Introduction

Detailed comments on scheme as proposed in consultation.

9 Sheet 9 Foot of the Walk to Jane St

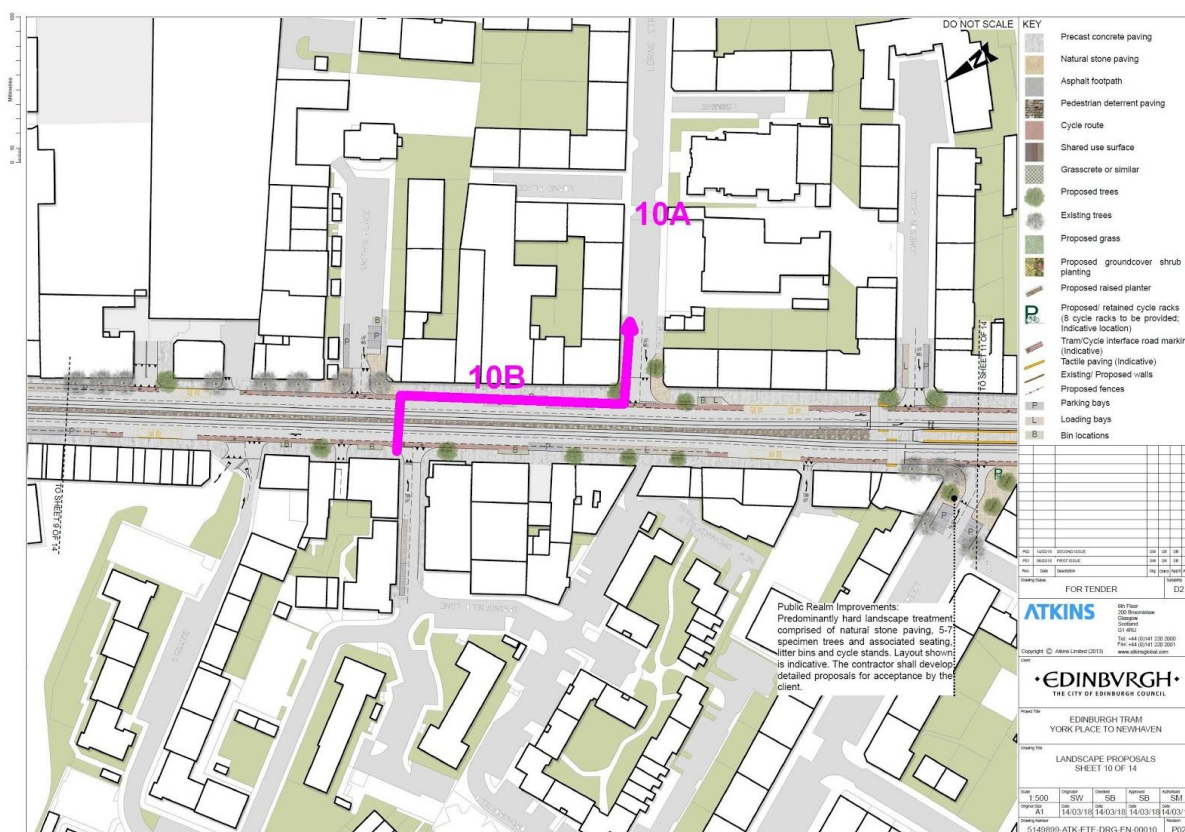
9A Spokes proposes (see 8A) that the tram stop is moved from Constitution Street to the Foot of the Walk (indicative location shown) and cycling infrastructure be provided on Constitution Street.

9B Tram tracks too close to kerb - no room for cyclists turning left from Duke Street.

9C Safe cycle crossings need to be provided at the junction of Leith Walk with Great Junction and Duke Streets. 2-stage crossings should be considered for some turns. There is an awkward angle for cyclists turning right from Leith Walk across the tracks into Duke Street - especially if the tracks are slewed enough to allow room for cyclists turning left from Duke Street into Leith Walk.

9D Dual one-way segregated cycleways should be provided for the length of Leith Walk. Parking/loading in on-road cycle lanes on Leith Walk render them unusable for cyclists of all ages and abilities and will force cyclists too close to the tram lines. **This layout is building in very severe danger - the Council is fully aware that many tramline cycle crashes occur when a cyclist wishing to travel parallel to the lines is forced into them by traffic pressures, such as vehicles moving out from the kerb.** The proposals are a significant reduction in the quality of the existing cycling facilities and public realm. Space could be provided by retaining the existing 2 traffic lanes and not increasing to 4 lanes as proposed. Additional space could be taken from the gardens on the West side (9F) that are used for storing bins - this may also free up space for the relocated tram-stop. Further space would also come from removing the median strip (9G). (See Area-wide comments A2 Leith Walk)

9E Consideration should be given to implementing some segregated cycleways on Great Junction Street, at least as far and connecting to Henderson Street, for access through to The Shore and other destinations to the North.

10 Sheet 10 Leith Walk to Balfour Street and tram-stop

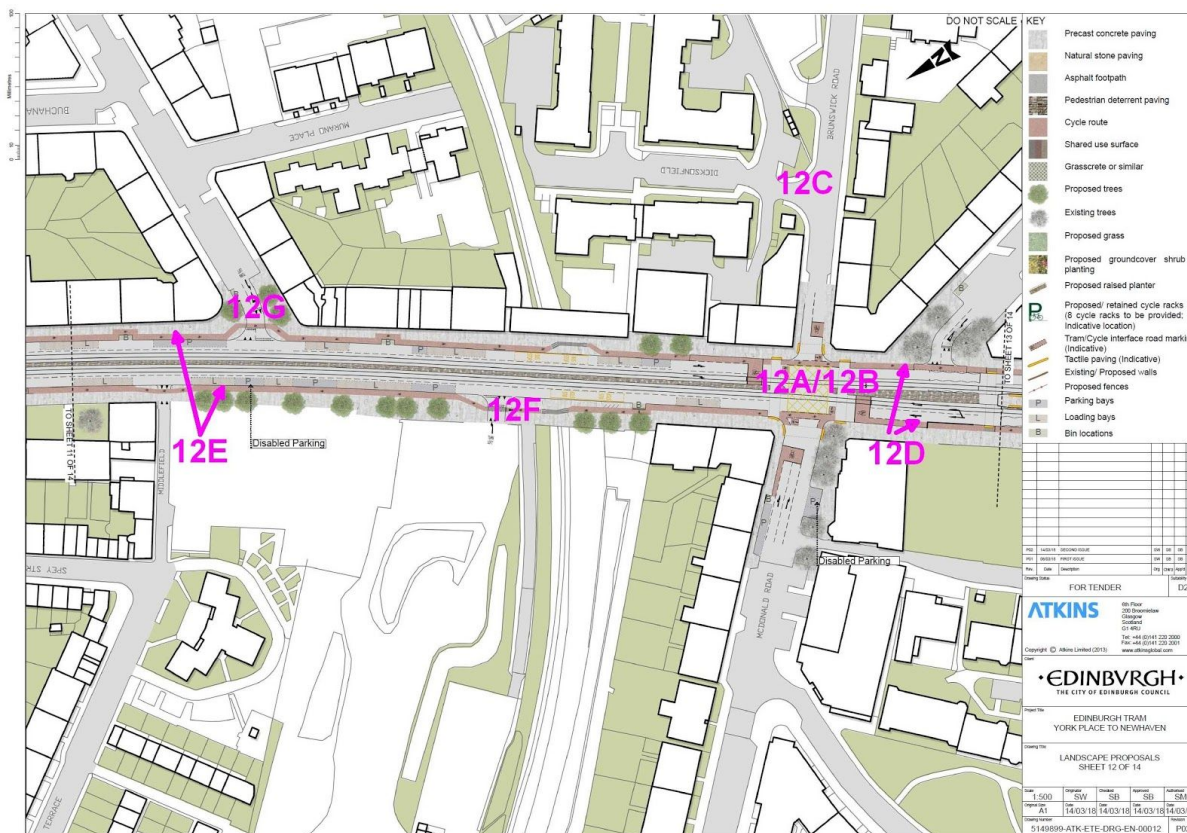
10A Lorne Street could be truncated/ made non-permeable to through motor traffic.

10B The area should be permeable to people on bikes, with connections between streets on the West and East sides of the Walk (eg Steads Place to Lorne Street), incorporating safe crossings of the tram tracks. The current proposals would make it impossible to cycle from the city centre via Leith Walk to any of the east-side streets north of Brunswick Road.

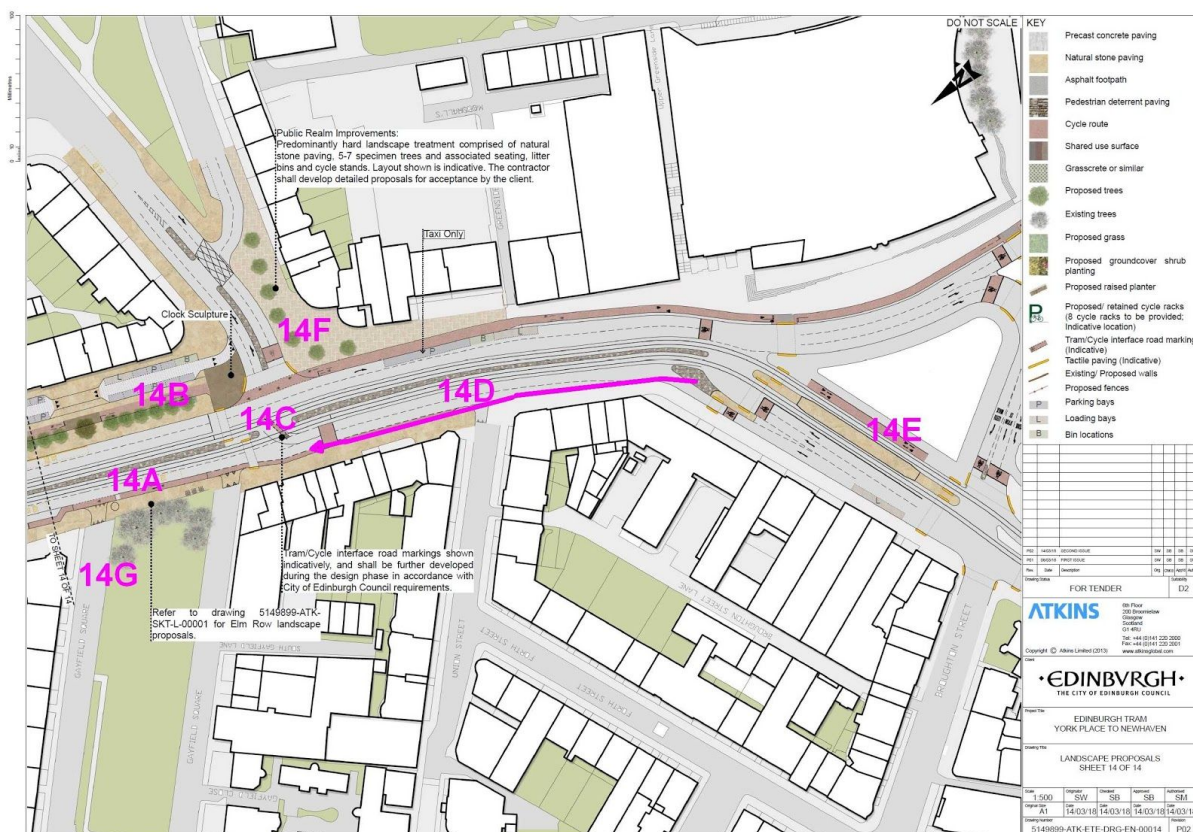
13B The Annandale Street junction design seems to continue the Leith Walk Programme proposals and it appears that the cycleways on Leith Walk are on the pavement and that cyclists will need to cycle on the pavement in order to make 2-stage turns at the junction. The cycleways should be instead be treated as being part of the road, though kerb-separated, and cyclists should have separate space for crossing without needing to use shared pavement, similar to the junction arrangement at McDonald Road.

13C There is a convoluted, seemingly conflicting and unprotected route proposed for cyclists crossing from Montgomery Street to Annandale Street/Leith Walk. This needs to be redesigned to solve these problems.

13D Cycle crossings should generally be on the inside of the junction and pedestrians to the outside, the opposite of what is shown.

13F Spokes believes that the 2-way segregated cycleway from Leith Street/Picardy Place should become 1-way segregated cycleways as early as possible - probably at the London Road junction. Spokes does support the continuation of the 2-way cycleway from Leith Street/Picardy Place as far as Montgomery Street, but this must be in addition to a northbound segregated on-road cycleway from London Road. We are not supportive of the place-making proposals and feel that a more appropriate design should be sought that retains the cycleway (See comments on Sheet14.)

13G The cycleway makes difficult 90-degree turns around this bin. We assume that this won't be the case in practice, particularly given our proposal for redesigned kerb-separated cycleways..
